**City of Willow Park
City Council
Special Called Meeting Agenda
Municipal Complex
516 Ranch House Rd, Willow Park, TX 76087
Tuesday, May 21, 2019 at 8:00 a.m.**

1. Discussion/ Action: To consider and act on a revised Site Plan for a hotel in the PD Commercial/ IH-20 Overlay District on Lot 12R, Block B, Crown Pointe Addition, Located at 338 Shops Blvd.

P & Z AGENDA ITEM BRIEFING SHEET

Consider and act on a revised Site Plan for a hotel in the PD Commercial/IH-20 Overlay District on Lot 12R, Block B, Crown Pointe Addition located at 338 Shops Blvd.

SITE PLAN

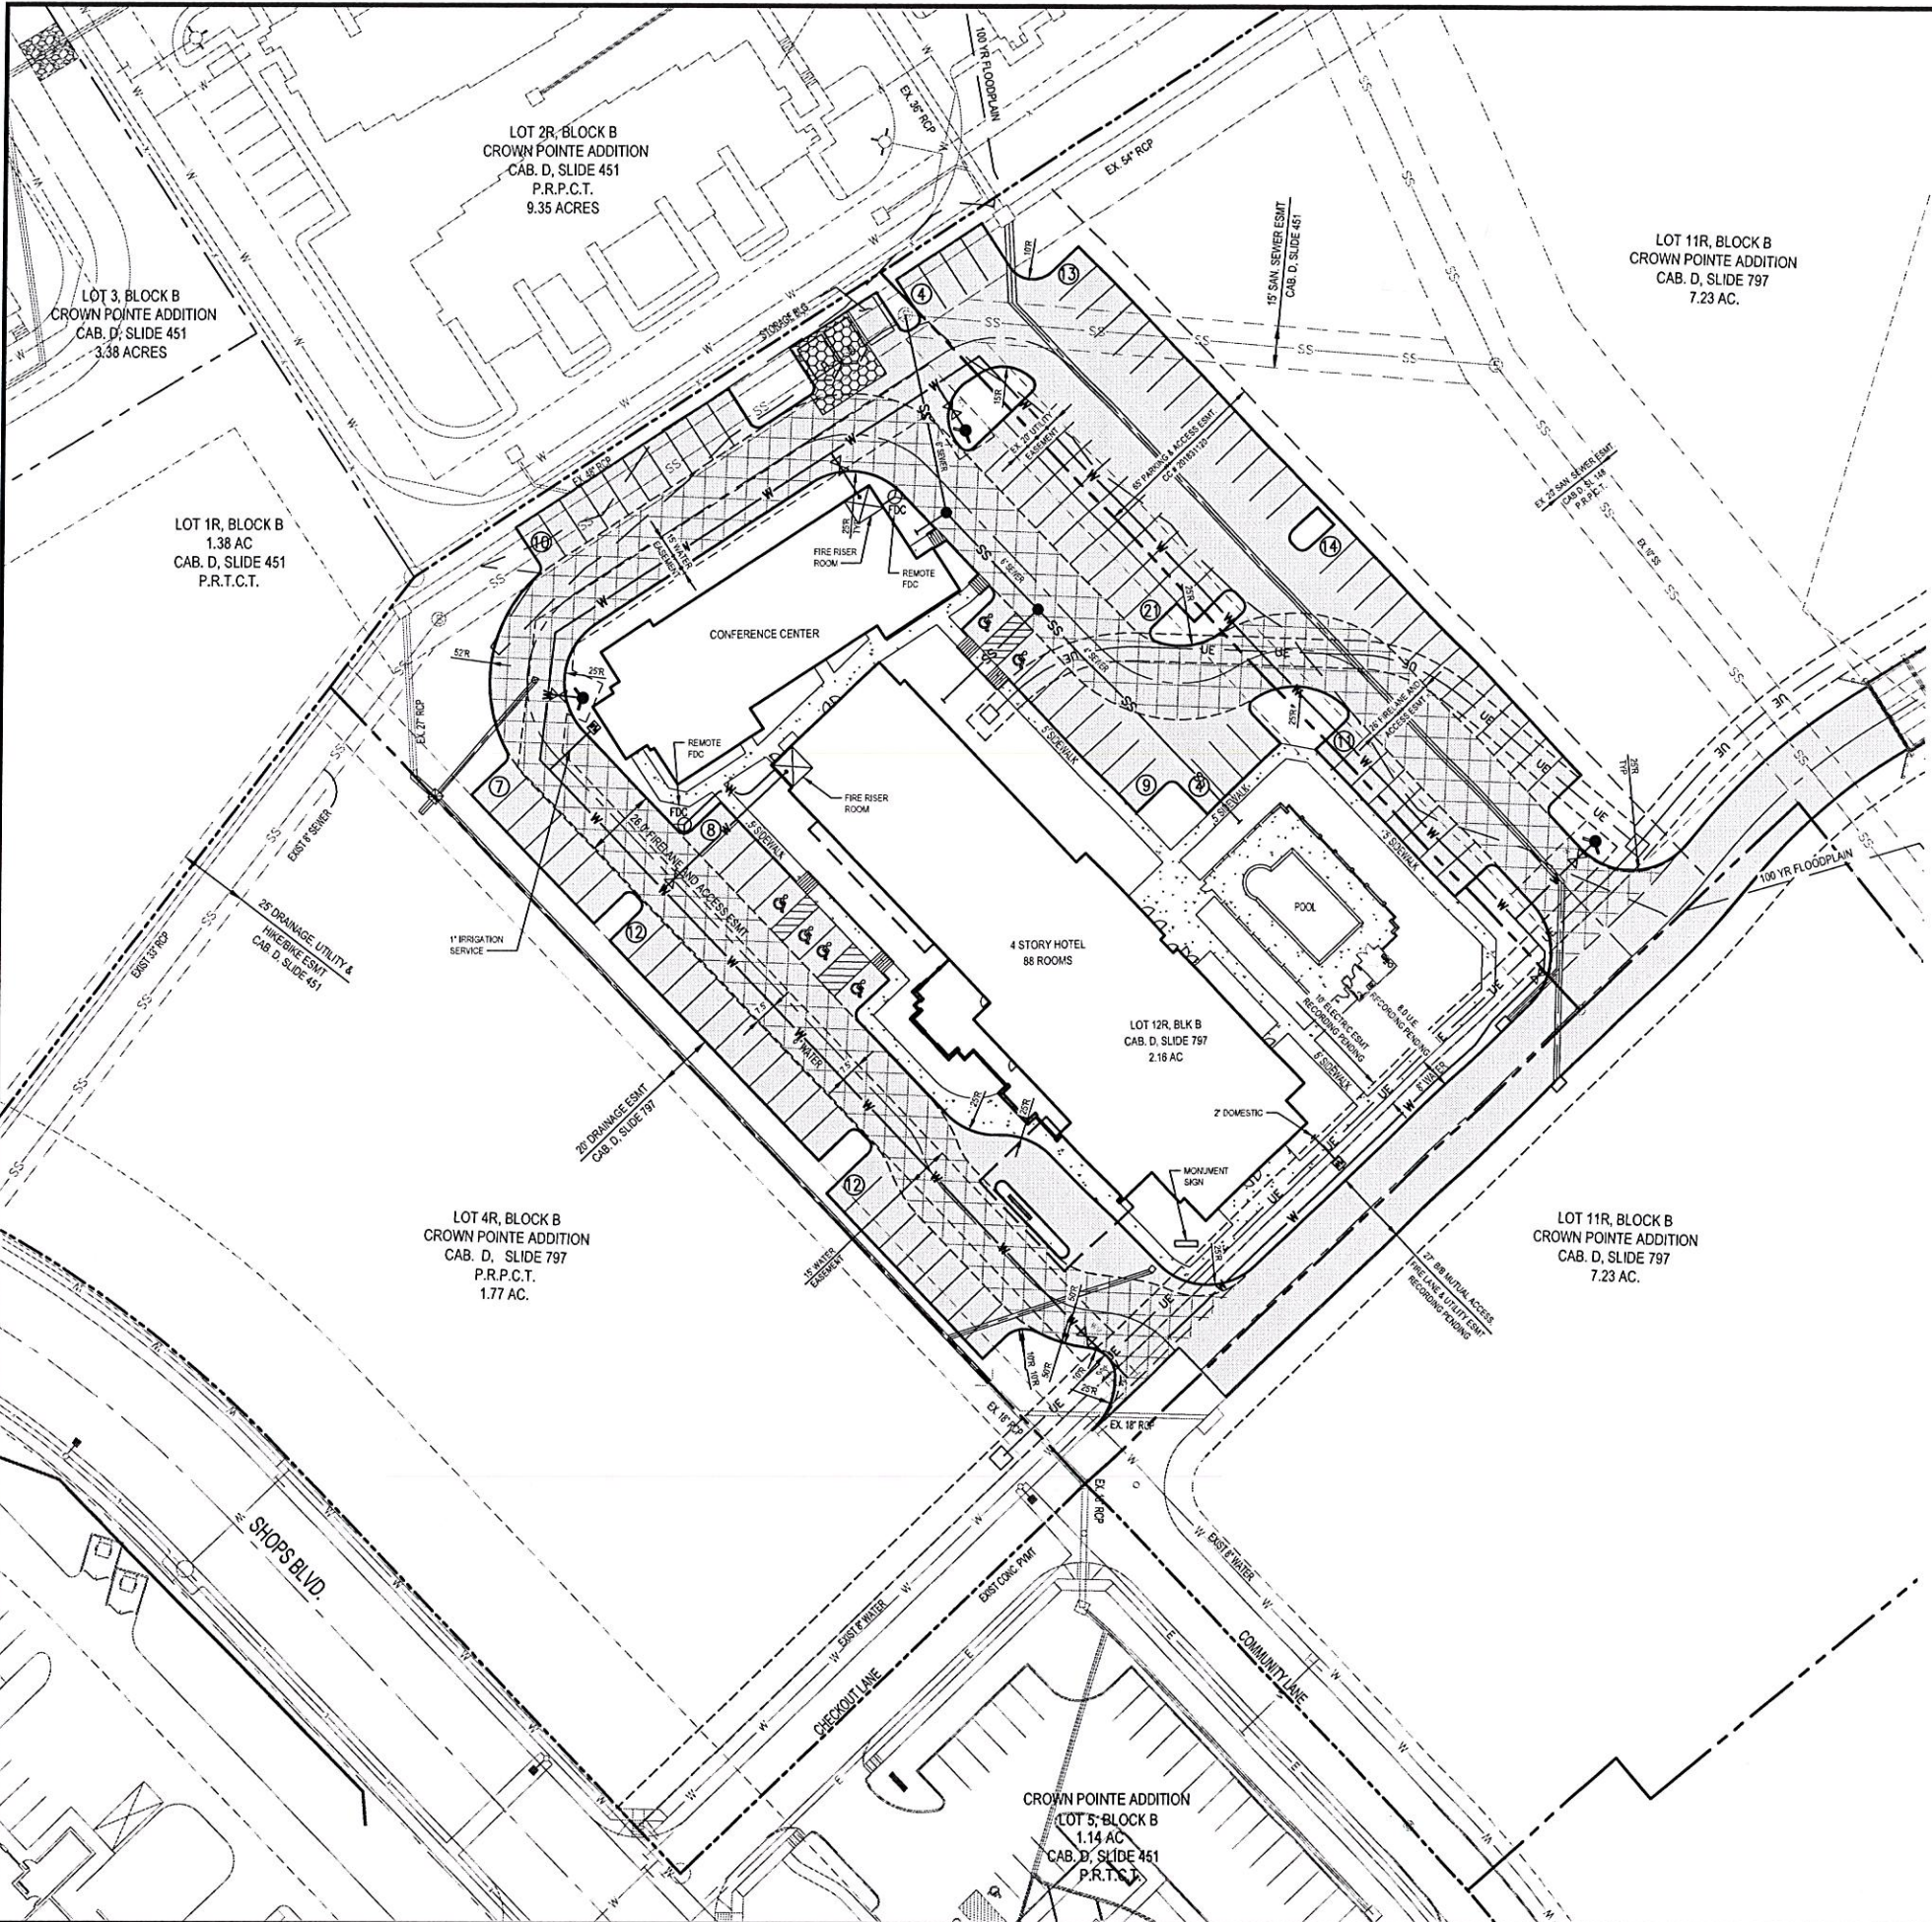
Staff recommends approval of the Site Plan for Lot 12R, Block B, Crown Pointe Addition, as revised, with the following required for final approval:

1. Stormwater drainage study and drainage improvement plans required.
2. Finished floor elevations required for structures in 100 year flood plain.
